<b>Committee Date</b>	22.02.2024	
<b>Address</b>	Car Park High Street West Wickham	
<b>Application Number</b>	23/04247/FULL2	<b>Officer</b> - Susanna Stevenson
<b>Ward</b>	West Wickham	
<b>Proposal</b>	Change of use of 14 car parking spaces (bays) in a car park to be used as space for a car wash including container for storage and staff office.	
<b>Applicant</b>	<b>Agent</b>	
APCOA Parking (UK) Ltd	Mr Neil Jones	
c/o agent NL Jones Planning Duke House, Duke Street Skipton BD23 2HQ United Kingdom	Duke House Business Hub Duke Street Skipton BD23 2HQ	
<b>Reason for referral to committee</b>	Council-owned site and Call in.	<b>Councillor call in</b> Yes – <b>Cllr Mark Brock</b> - Loss of further parking spaces to the High Street Loss of amenity for the residents that this will directly affect (noise, spray etc.). Call in conditional – should it be recommended that planning permission be granted.

<b>RECOMMENDATION</b>	Application Refused
-----------------------	---------------------

**Figure 3 – Car park layout (proposed)**

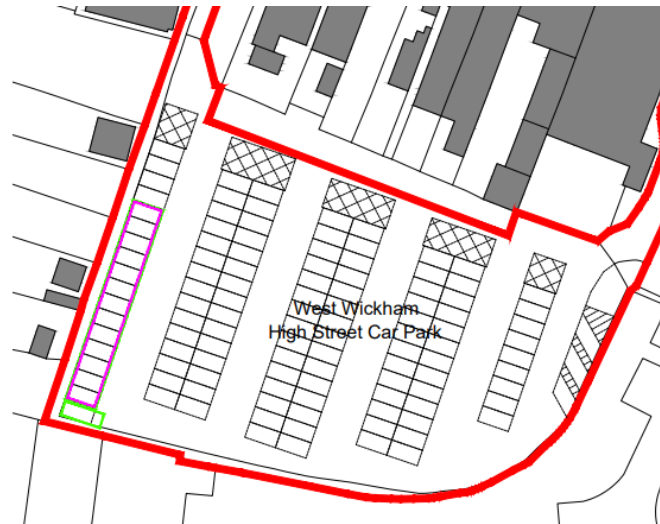
2.6 However, it was observed on site that the layout of the existing parking bays does not precisely tally with that indicated on the submitted drawings – with the information within the application not reflecting the current layout which includes new disabled bays positioned in the western row of parking spaces. The submitted block plan indicates with a red line that the development would consume 14 spaces, with 4 no. spaces retained between the car wash site and the yellow box markings. On site the spaces between the south western corner of the car park and the barrier/box markings were counted as comprising 12 regular sized bays, with 4 disabled bays.

- 7.2.6 It was noted on site that the submission does not accurately show the layout of the car park as existing, in terms of the potential number of spaces impacted and with regards to the 4 no. disabled parking spaces. It is unclear also, in terms of the drawings and example of acoustic enclosure included in the Noise Impact Assessment, how practicable the manoeuvring of vehicles into and out of the bays to allow operative access while maintaining the passage of non-car wash vehicles along/adjacent to the bay would be.
